Addendum No. 4

Re: Part B - James M. Seals, JR. Park – Athletic Restroom/ Concession and Field Improvements
504 Texas Street, Mobile, AL 36603
Project No. PR-041-20
Part C - Hackmeyer Park – Improvements Phase 2
3810 Conway Drive South, Mobile, AL 36608
Project No. PR-034-21

Date: December 5, 2022

P1.1

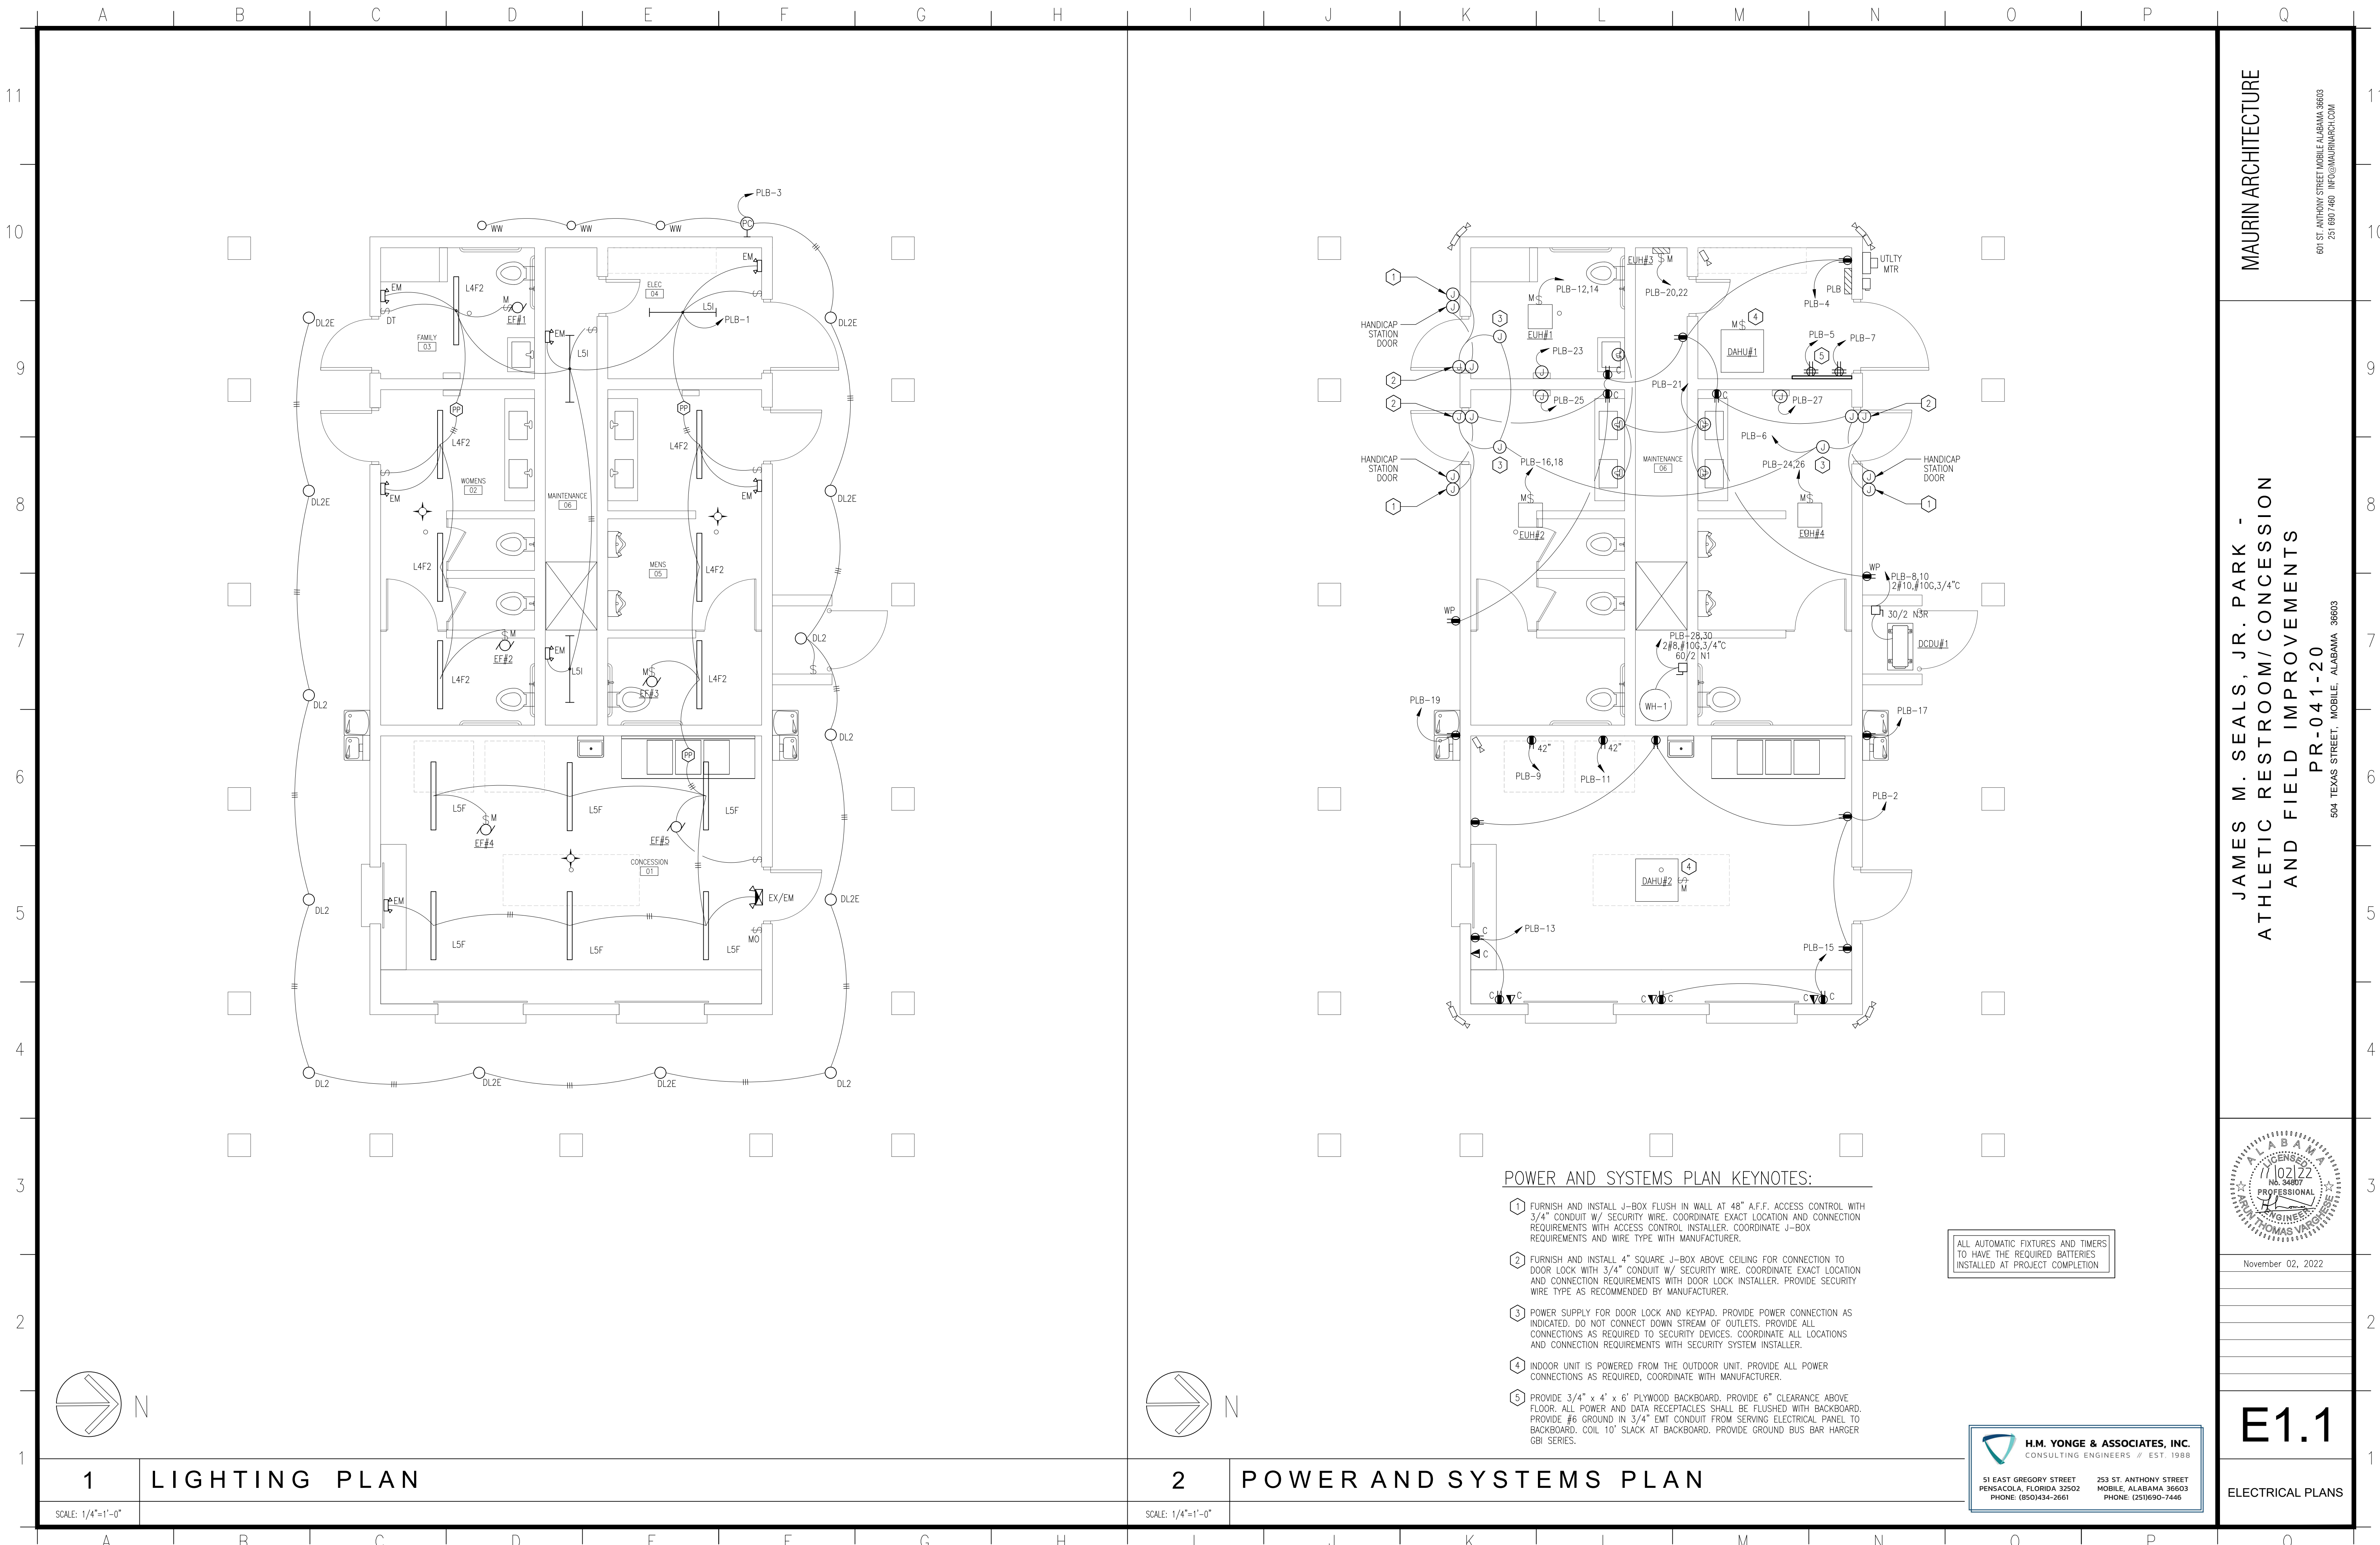
- Item 2: Sheet P1.1 Plumbing Plans Sheet
Replace this sheet dated 11.02.22 with the attached revised sheet of same title P1.1, dated December 5, 2022 and labeled Revision 01 (Addendum No. 4). Substantial changes include the following:
Update drawing waste design per Plumbing permitting review comments, see attached.

2 PIP SAFETY SURFACE COATING

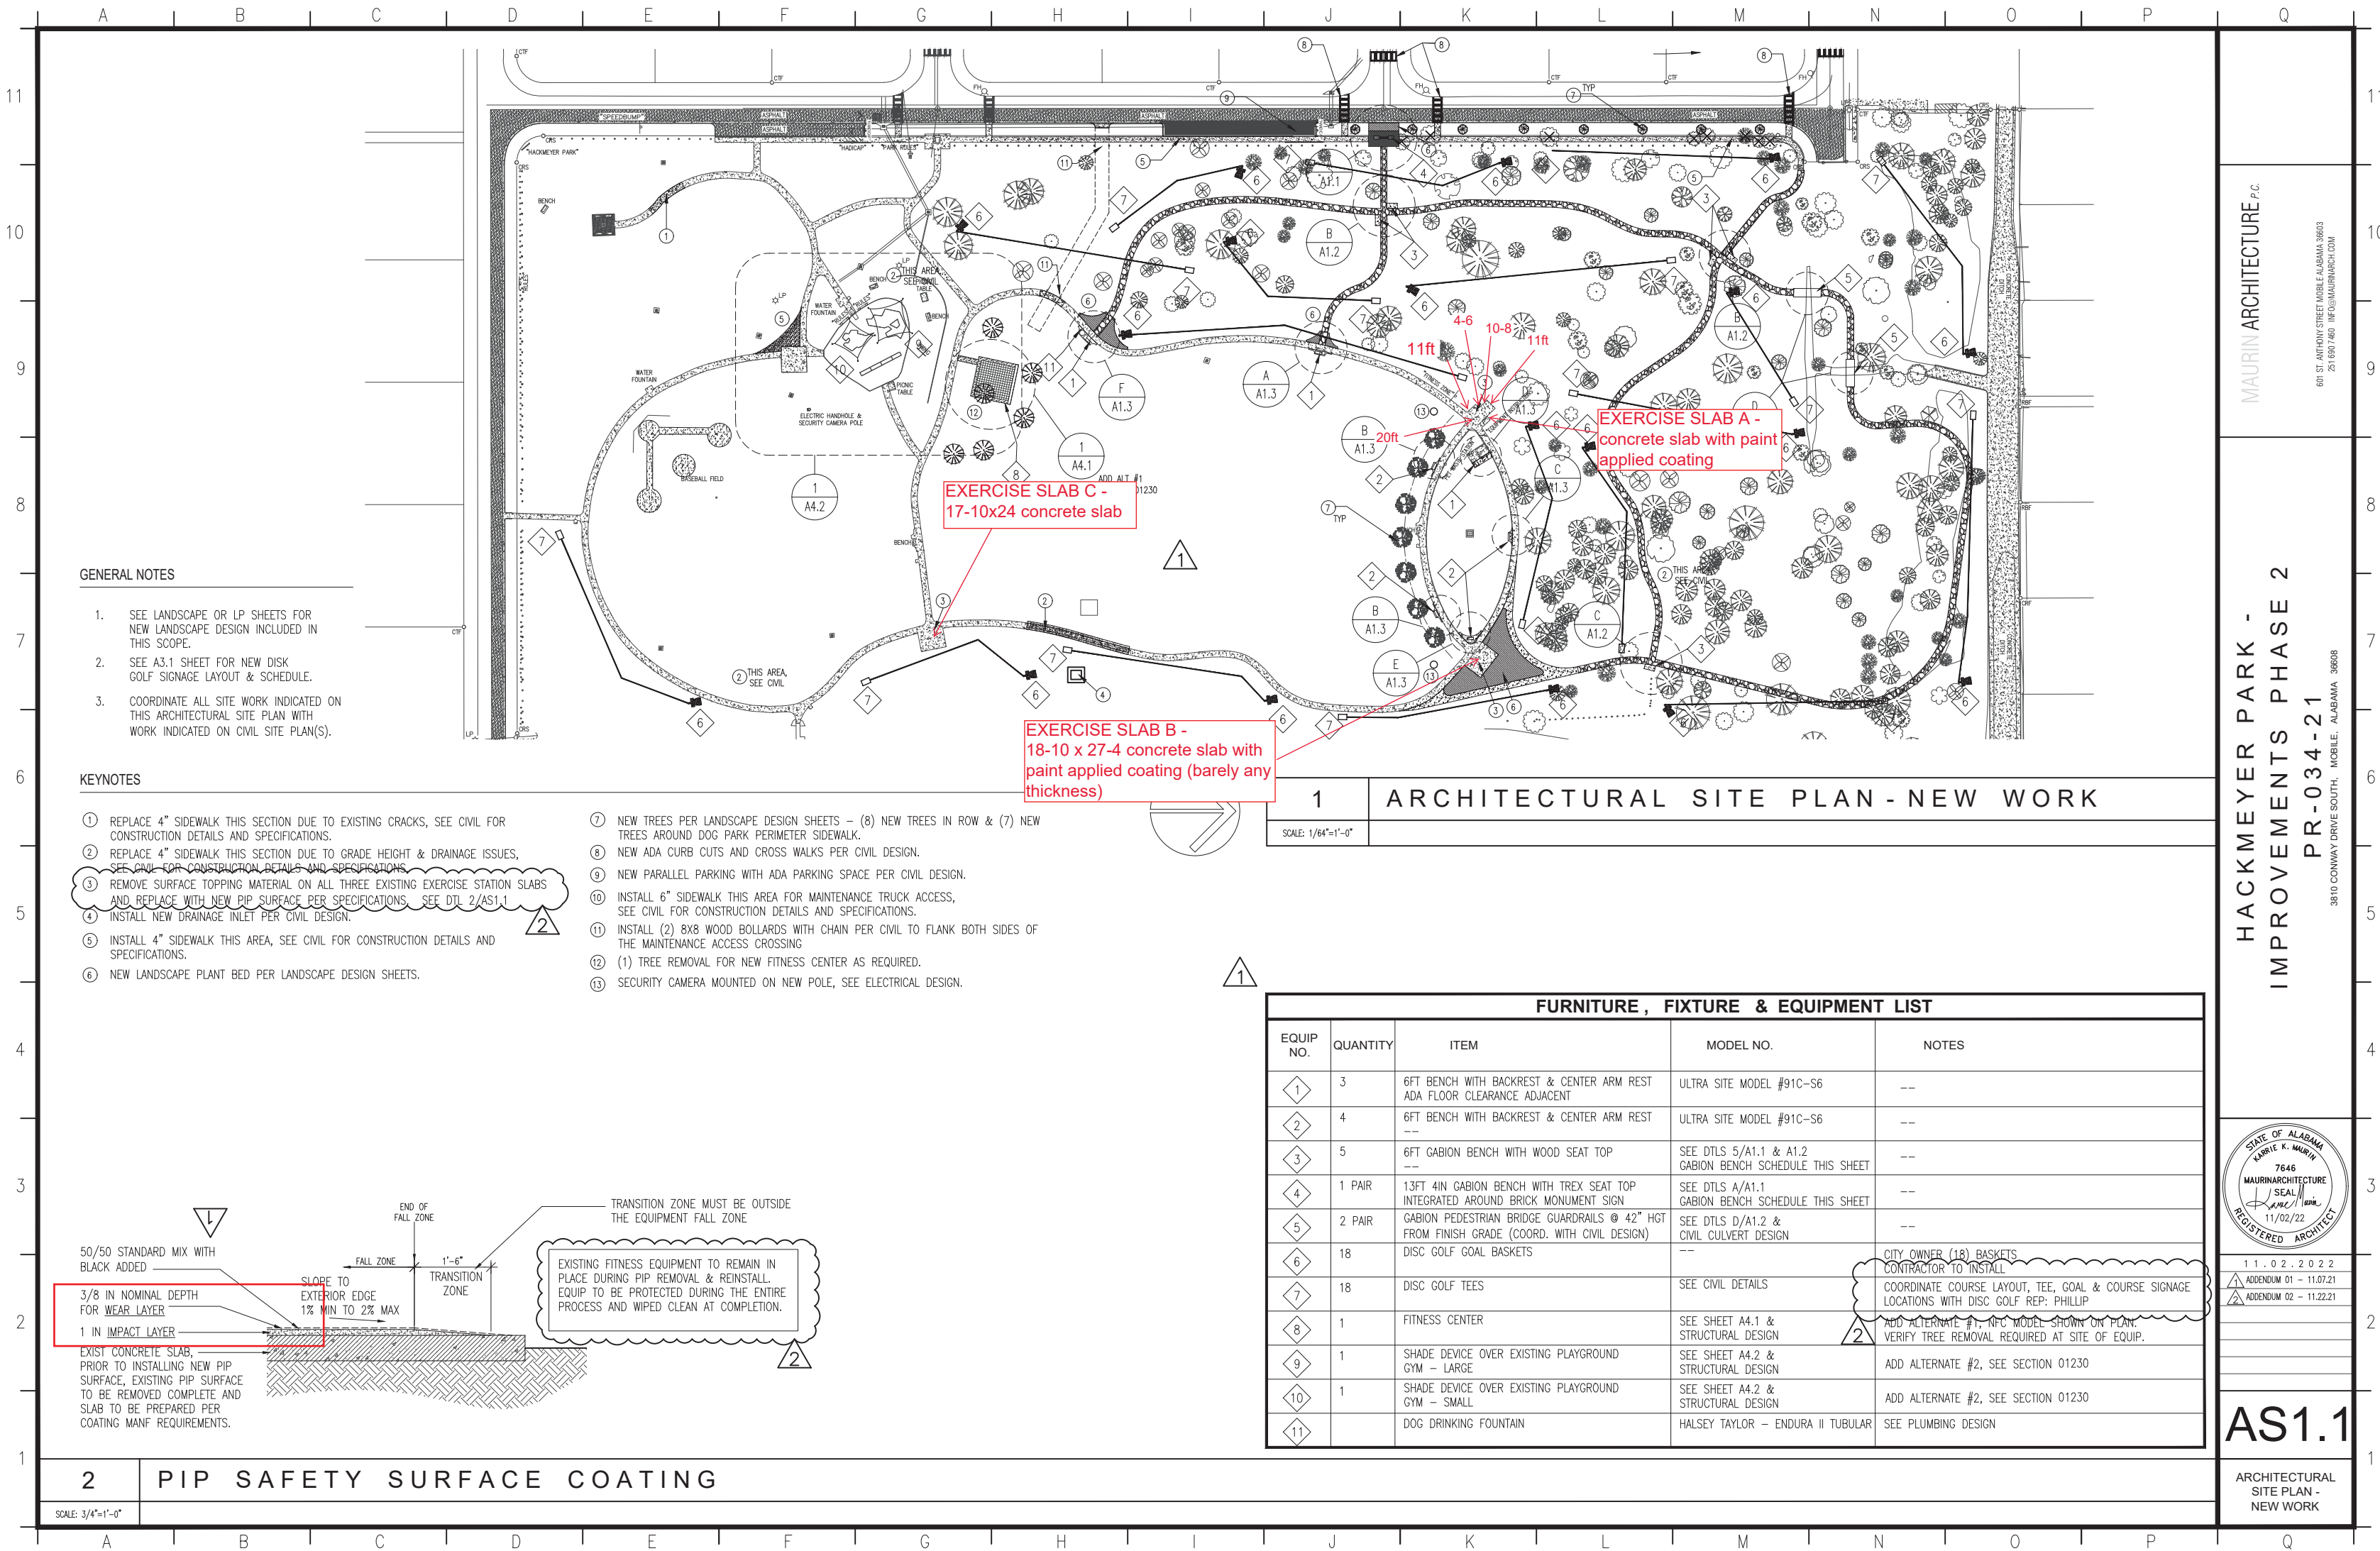
- Item 3. Please assume the PIP surface shall be installed up to the existing slab control joint against the sidewalk with “transition zone” per Dtl 2/AS1.1R02.
